**DEPARTMENT OF TRANSPORTATION**

Contract #: 04-0120F4Cty: SF/ALA Rte: 80 PM: 13.2/13.9File #: 69.25B**QUALITY ASSURANCE -- NON-CONFORMANCE REPORT****Location:** Changxing Island, Shanghai, P.R. China**Report No:** NCR-000960**Prime Contractor:** American Bridge/Fluor Enterprises, a JV**Date:** 28-Dec-2010**Submitting Contractor:** Zhenhua Port Machinery Company, Ltd (ZPMC), Changxing Island**NCR #:** ZPMC-0919**Type of problem:****Welding****Concrete****Other****Welding****Curing****Procedural****Bridge No:** 34-0006**Joint fit-up****Coating****Other****Component:** Bikepath BK004A-013**Procedural****Procedural****Description:**

**To:** AMERICAN BRIDGE/FLUOR, A JV  
375 BURMA ROAD  
OAKLAND CA 95607  
**Date:** 30-Dec-2010  
**Contract No:** 04-0120F4  
04-SF-80-13.2 / 13.9  
**Dear:** Mr. Charles Kanapicki  
**Job Name:** SAS Superstructure  
**Attention:** Mr. Thomas Nilsson Project/Fabrication Manager  
**Document No:** 05.03.06-000917  
**Subject:** NCR No. ZPMC-0919

Contract #: 04-0120F4Cty: SF/ALA Rte: 80 PM: 13.2/13.9File #: xx.25A**QUALITY ASSURANCE -- NON-CONFORMANCE RESOLUTION****Location:** Changxing Island, Shanghai, P.R. China**Report No:** NCS-000914**Prime Contra

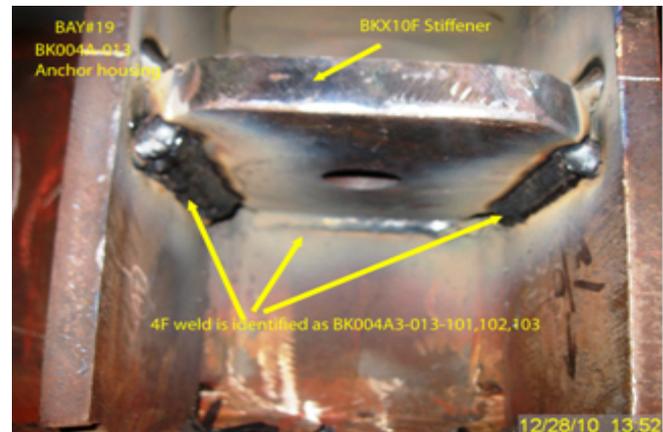
**Reference Description:** ZPMC welder performed welding in a position which he is not qualified to weld (Bikepath BK004A-013)

- ZPMC welder ID#062752 performed welding in a position in which he is not qualified according to his welder card.
- The welder is qualified to the 3G (FCAW) position.
- The welder was observed by this QA welding in the 4F position.
- There are three fillet weld joints completed by this welder in the 4F position.
- The welds are identified as BK004A3-013-101,102 and 103.
- The welds are fillet welds joint connecting the stiffener BKX10F to 25mm stiffener plate BKX11 and stiffener BKSA1A (Anchor Housing assembly).
- OBG Bike path is located inside bay 19.

**Reference Resolution:** ZPMC has removed the plate and welds, this plate was not on the drawing so ZPMC is providing NDT of the base metal where the plate and welds were removed.

This proposed resolution is acceptable. The documentation received is sufficient and the Department concurs that Non-Conformance ZPMC-0919 is closed.

**Component:** Bikepath BK004A-013

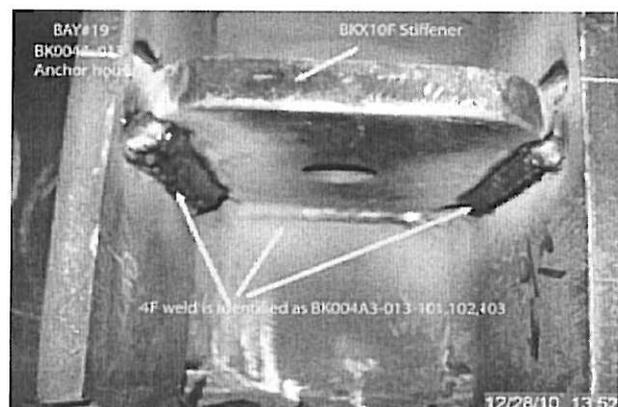
**Reference Description:** ZPMC welder performed welding in a position which he is not qualified to weld (Bikepath BK004A-013)

- ZPMC welder ID#062752 performed welding in a position in which he is not qualified according to his welder card.
- The welder is qualified to the 3G (FCAW) position.
- The welder was observed by this QA welding in the 4F position.
- There are three fillet weld joints completed by this welder in the 4F position.
- The welds are identified as BK004A3-013-101,102 and 103.
- The welds are fillet welds joint connecting the stiffener BKX10F to 25mm stiffener plate BKX11 and stiffener BKSA1A (Anchor Housing assembly).
- OBG Bike path is located inside bay 19.

Contractor will remove the non-conforming welds, and submit the Critical Welding Report. As this plate is not on the drawing Contractor will perform NDT on the base metal where the plate has been removed. Contractor will issue an internal NCR to the QC personnel involved.

Contractor removed the welds, and repaired as Critical Welding Repair to the approved procedure. NDT report has been provided proving the base metal is acceptable after repair. ZPMC issued an internal NCR to the QC personnel.
